**Development of a TMDL to Reduce NonPoint Source Sediment
Pollution in Deep Creek, Montana**

Report to Montana Department of Environmental Quality

March 1996

ERRATA SHEET FOR THE DEVELOPMENT OF A TMDL TO REDUCE NONPOINT SOURCE SEDIMENT POLLUTION IN DEEP CREEK, MONTANA

Figure 22. Diagram of juniper revetment for stabilizing outer meander bend

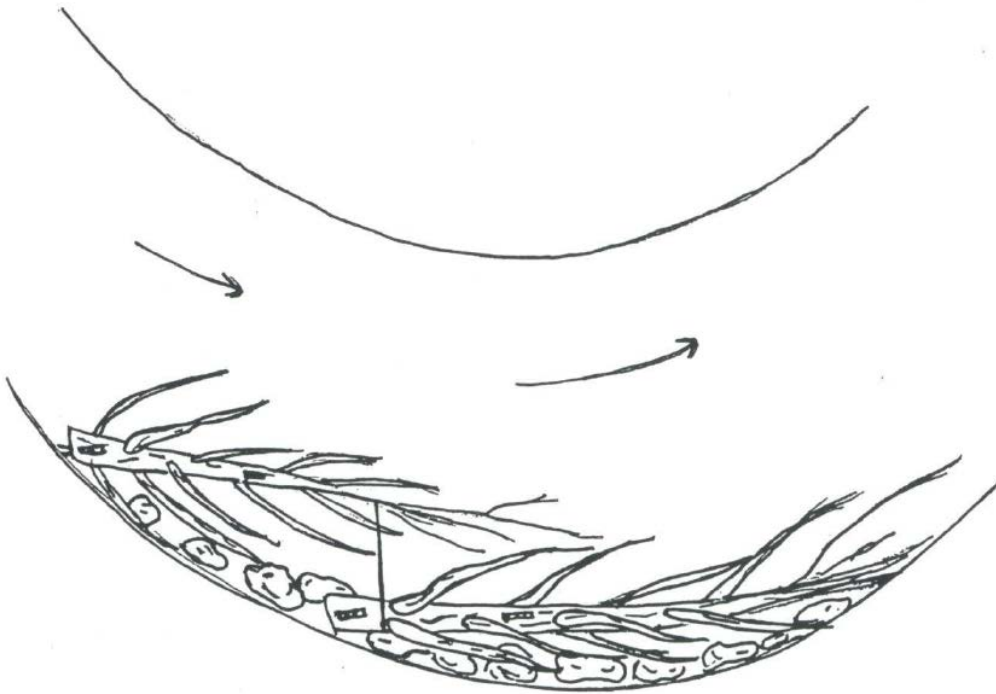
- Page 52, Figure 21. Figure re-numbered as Figure 22.
 - **Figure 22. Diagram of juniper revetment for stabilizing outer meander bend**
- Page 94, Added 5 figures and added label numbering in Appendix C (originally Appendix D starting on page 94):
